| Intersection ID: 10023803 | Main Street: COLONY_RD | Cross Street: N/A | Location: | SW |
| ADA ID: B91E1F857102 | Ramp Type: PerpDiag | Initial Pass/Fail: Fail | Overall Compliance: No | Severity Score: 12.5 |

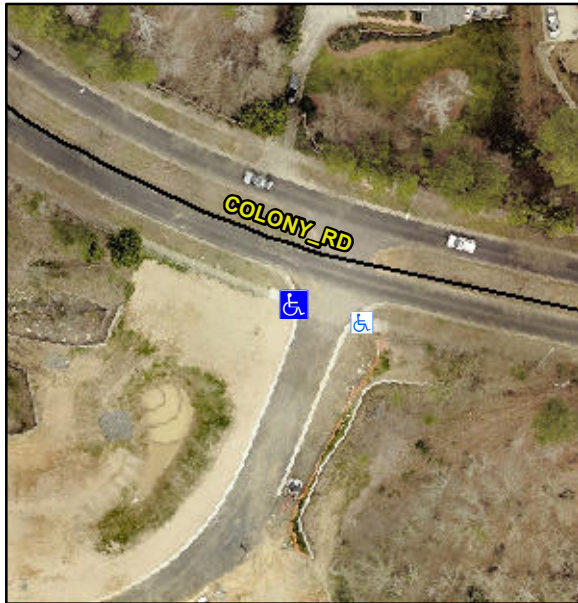
Not Found, R304.2.2

| Compliance | Description | Data | Compliance | Description | Data |
|------------|-----------------------|-------|------------|-----------------------------|-------|
| N/A | Ramp Length (in) | 68.0 | No | Ramp Slope (%) | 9.0 |

Remove & Replace Curb Ramp With Two New Directional Ramps or Equivalent.
